OCEAN COUNTY HEALTH DEPARTMENT

PLOT PLAN & SEPTIC SYSTEM DESIGN

On March 31st, 1994, representatives from this Department visited the above stated job site. It appears that the engineer who designed the plan for the above may have submitted incorrect information regarding the seasonal high water table (S.H.W.T.). Direct observation of the Seasonal High Water Table at the site disclosed substantially higher S.H.W.T. than the approved plan indicated.

REG. NO.	REMARKS (Please specify area)
	PLAN REVIEW, SEPTIC + WELL, (REVISION, TINA) BLK 83
	LOT 16,19
	REJECT
4.7,	BECAUSE S.H.W.T. IS LESS THAN 1.5 ft FROM EXISTING GRADE,
3.5c	(S.H.W.T = 12"), PROOF OF COMPLIANCE WITH FRESHWATER WETLANDS
—	REGULATIONS AS PER CODE IS REQUIRED (NOTE - USE OF 4.7c4 IS NO
—	LONGER ACCEPTABLE), ALONG WITH ANY WETLANDS LINES TO BE
—	INDICATED ON PLAN.
3.5c	INDICATE LOCATION OF ALL SOIL PITS AND BORINGS ON SITE & WITHIN
—	150 ft (TO INCLUDE BORINGS USED TO DETERMINE S.H.W.T OF 12")
—	SOIL LOGS ATTACHED TO SUBMISSION COMBINE WITNESSINGS OF JULY 93
—	WITH WITNESSINGS DONE IN SPRING OF 94)
3.5c	LUR 600A DOES NOT INDICATE CODE SUBCHAPTERS NOT IN
—	COMPLIANCE WITH REGULATIONS (7:9A)
10.6	THE 2 ft FILL PERIMETE

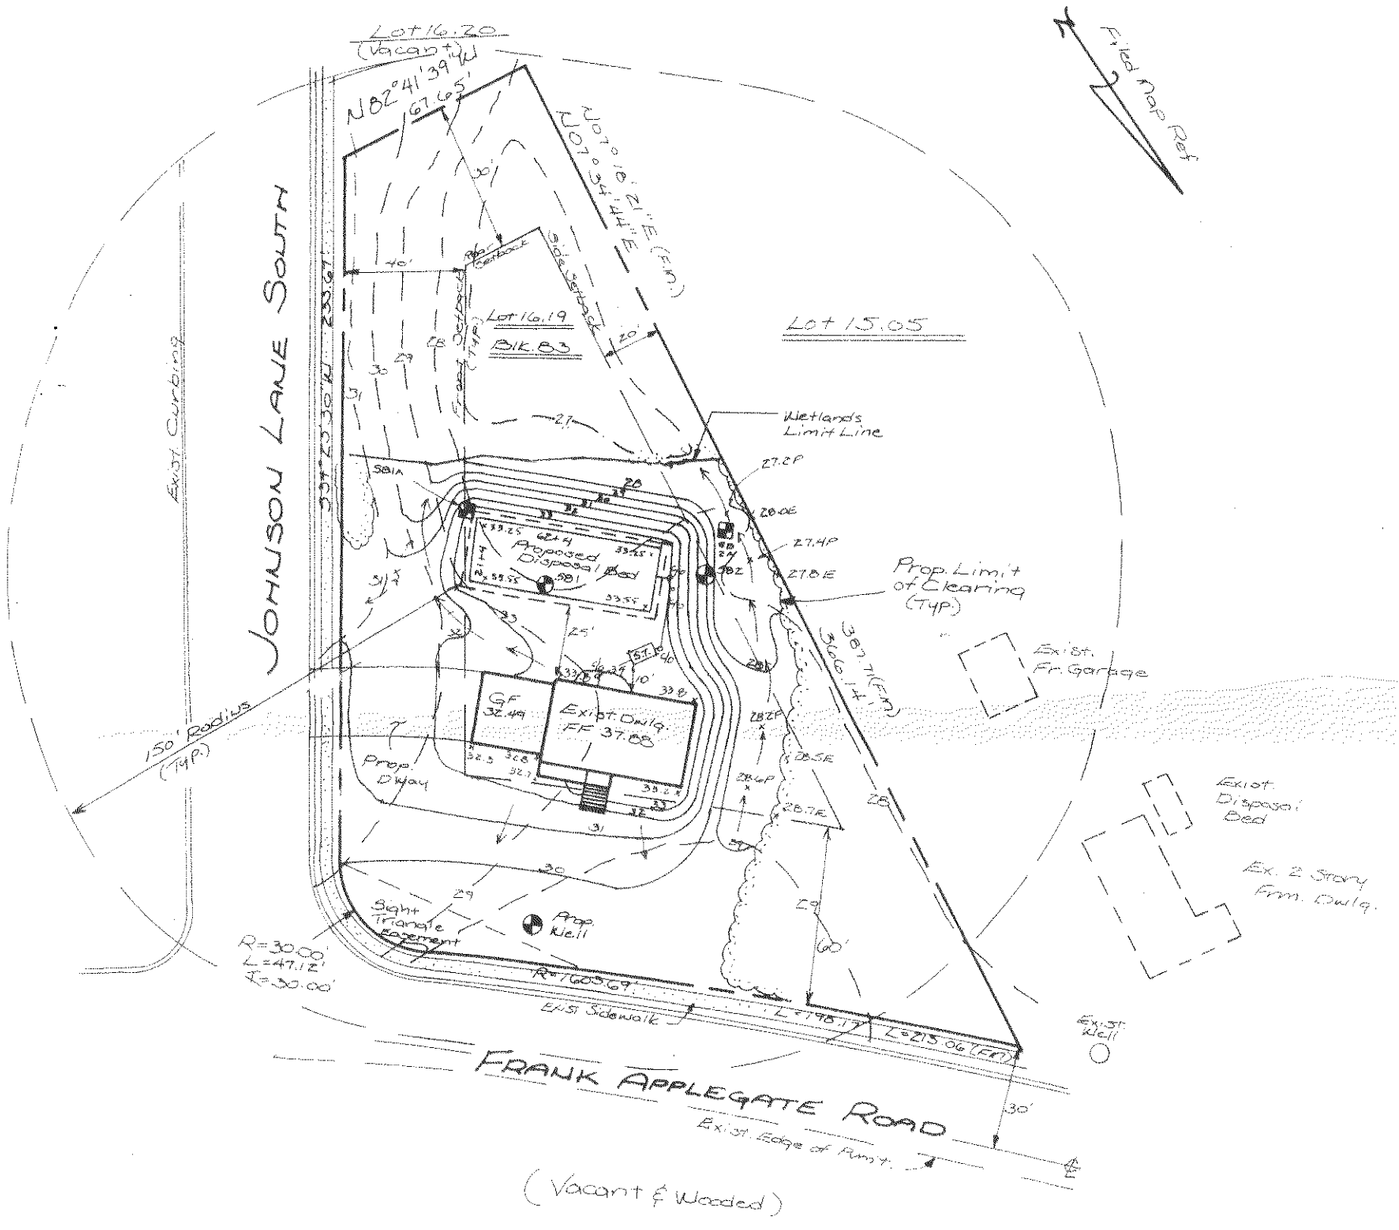
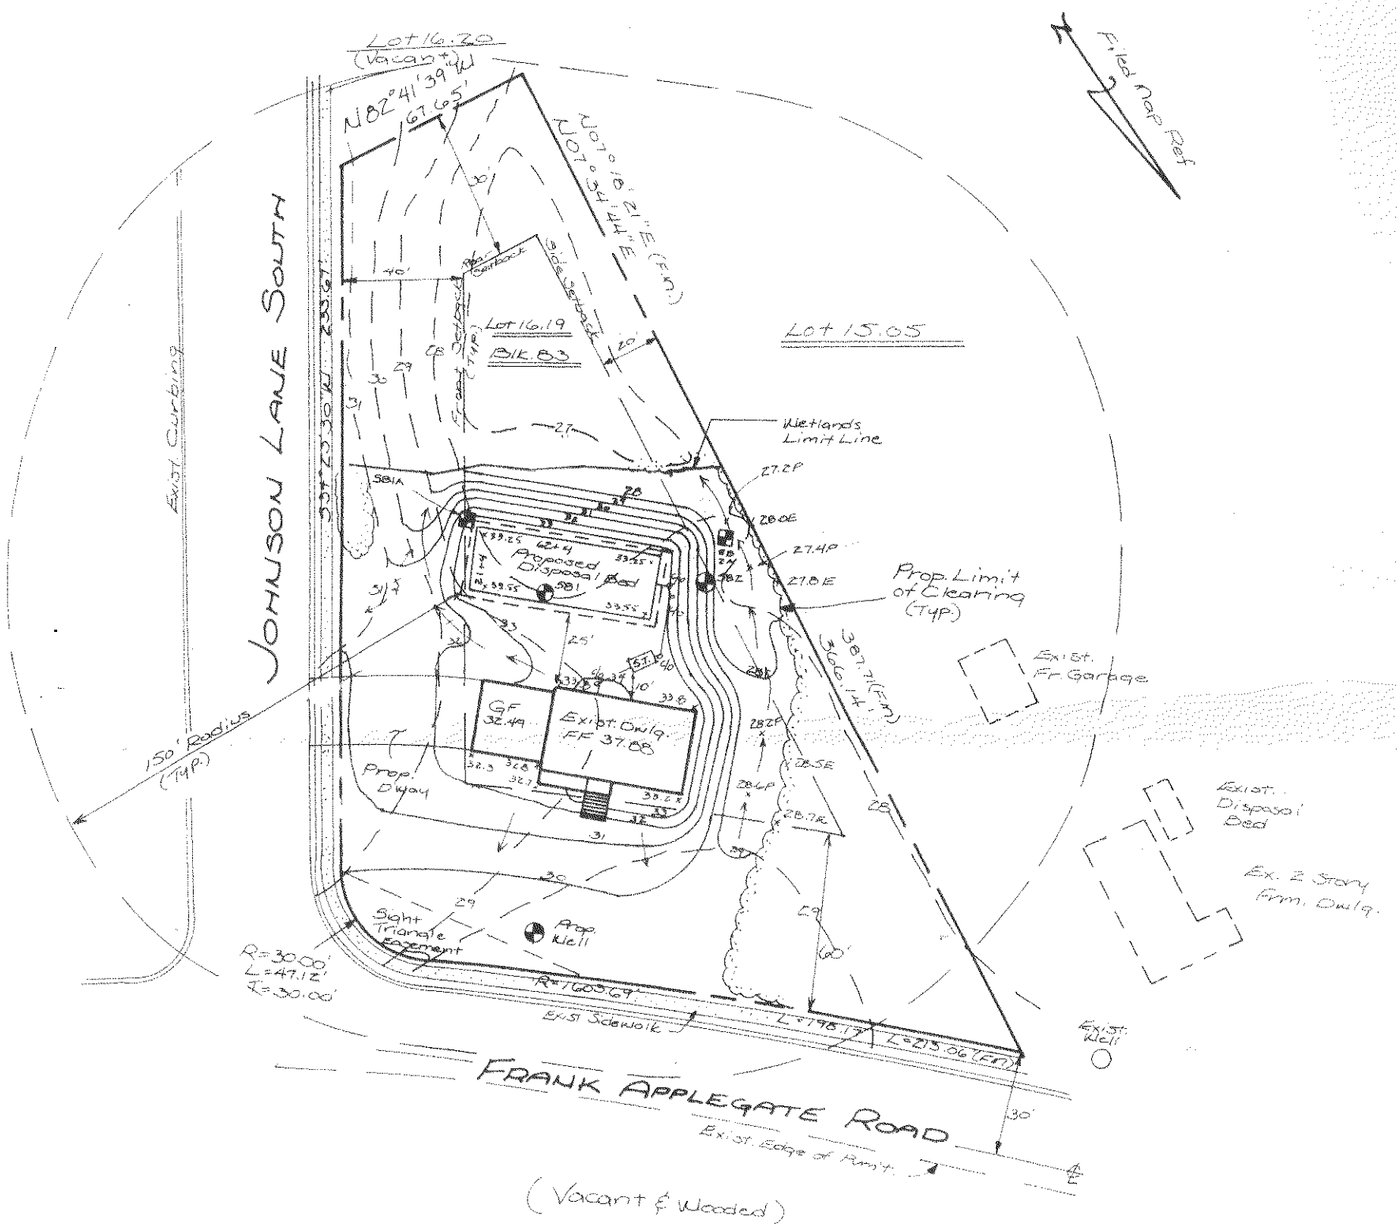
PLAN APPROVED RE—TWA. 1511-94-0018.1 AND WETLANDS WAIVER CORP 1511-94-0017.2. F. MAGUE, O.C.H.D 12/6/94
PLAN REVISED 7/27/94 APPROVED 8/15/94 WITH STIPULATIONS PENDING APPROVAL BY TREATMENT WORKS/DEP&E

REV.	DATE	DESCRIPTION	CHK'D	APPR'D.
3	7-27-94	Added Wetlands Line, Rev. as per O.C.H.D.	RJM	RJM
2	6-1-94	Revised As Per O.C.H.D.	RJM	RJM
1	9-17-93	Revised As Per Twp. Engr.	RJM	RJM

BLK 83, LOT 16.19

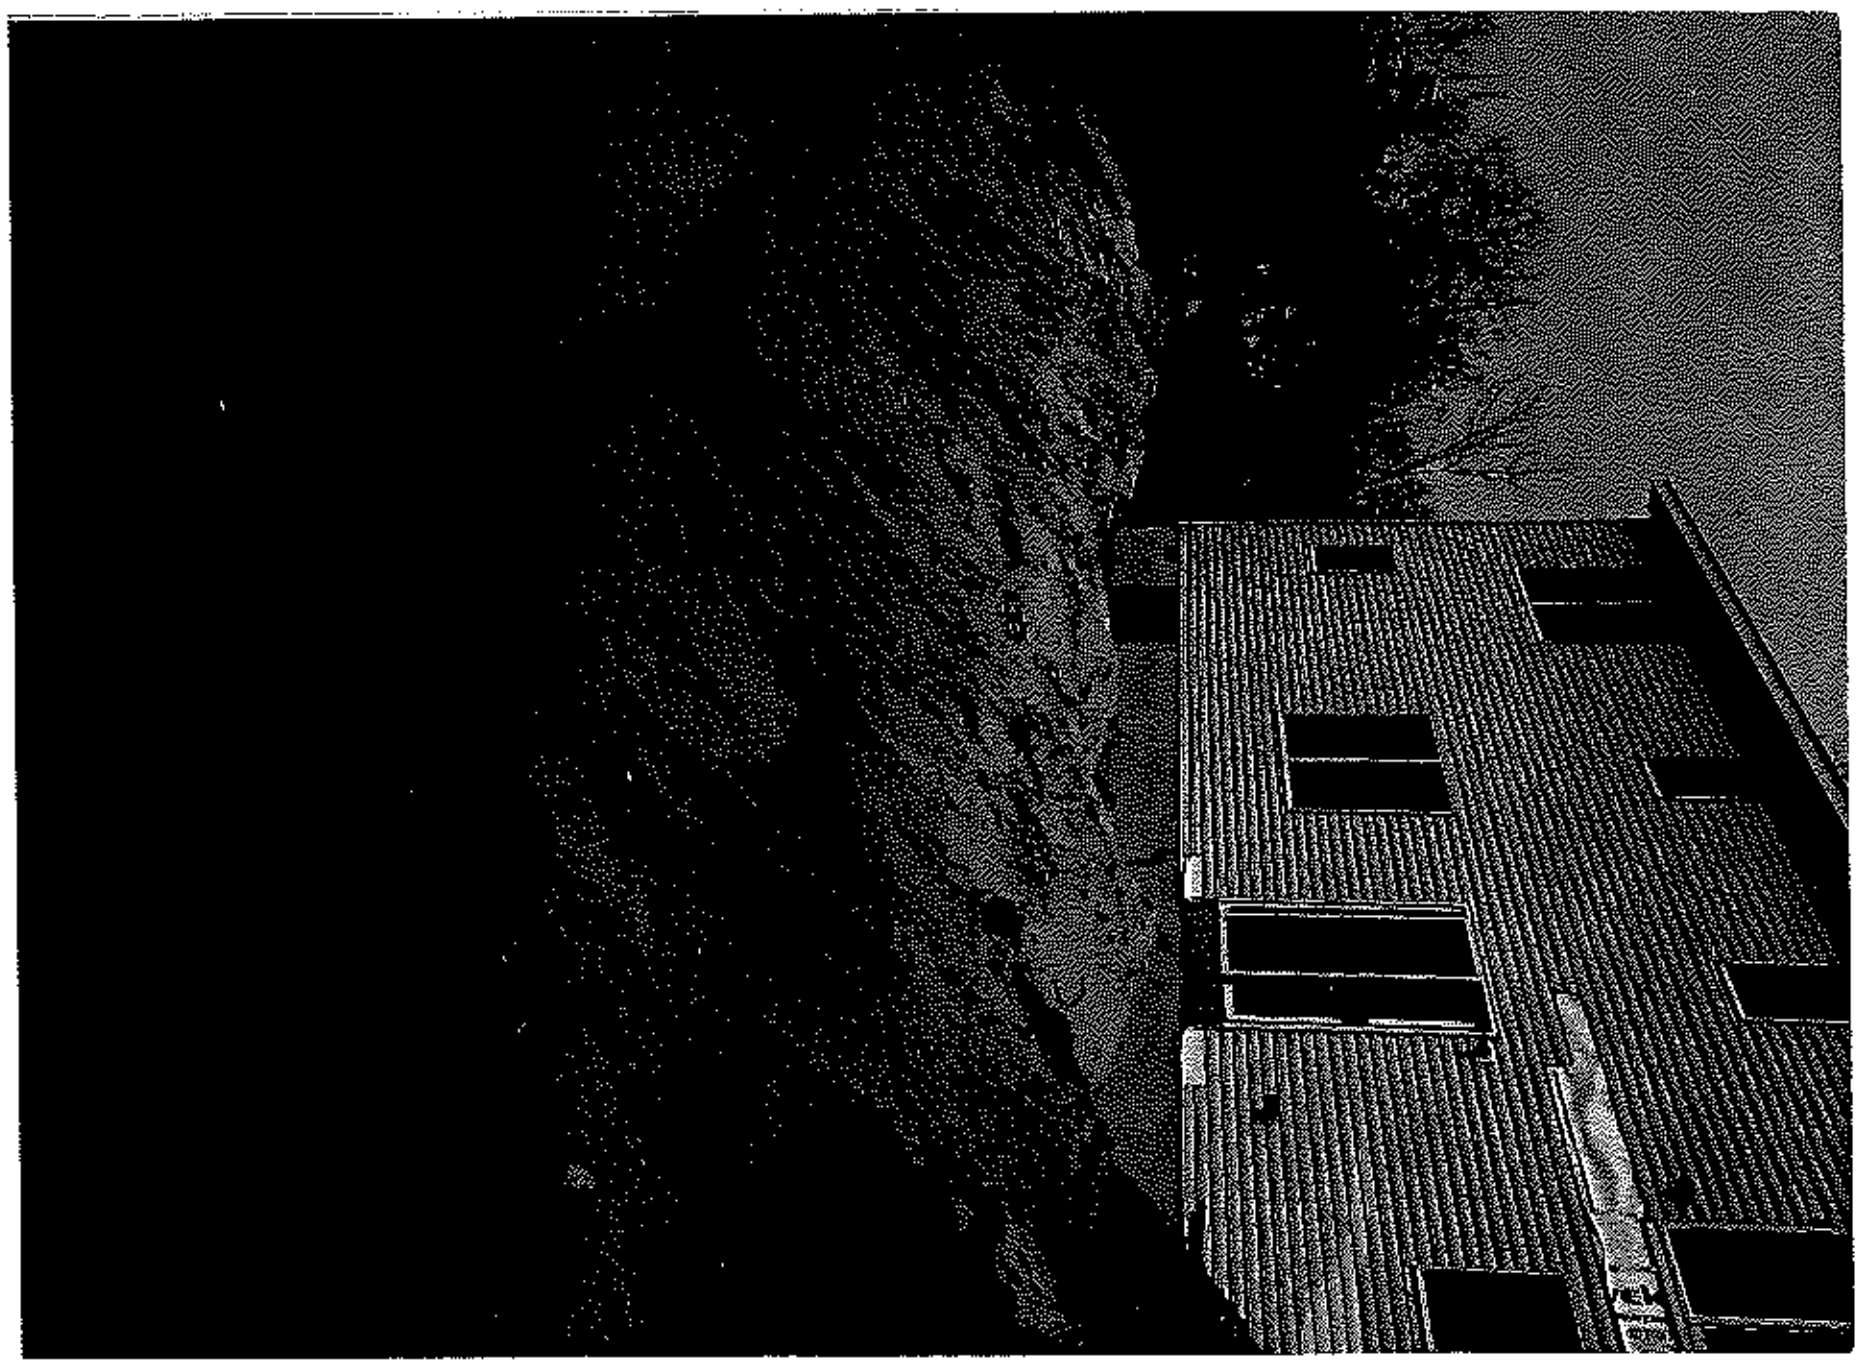
3/31/94 PHOTO BY D. GALLOS,
SUPERVISOR, O.C.H.D., ENVIRONMENTAL
DEPT (WITNESSED BY F. MARCHESE,
SANITARY INSPECTOR)

SHOWING FLOODING OF EXCAVATION FOR SEPTIC, LOCATED TO REAR OF BLDG (IN PIC.)
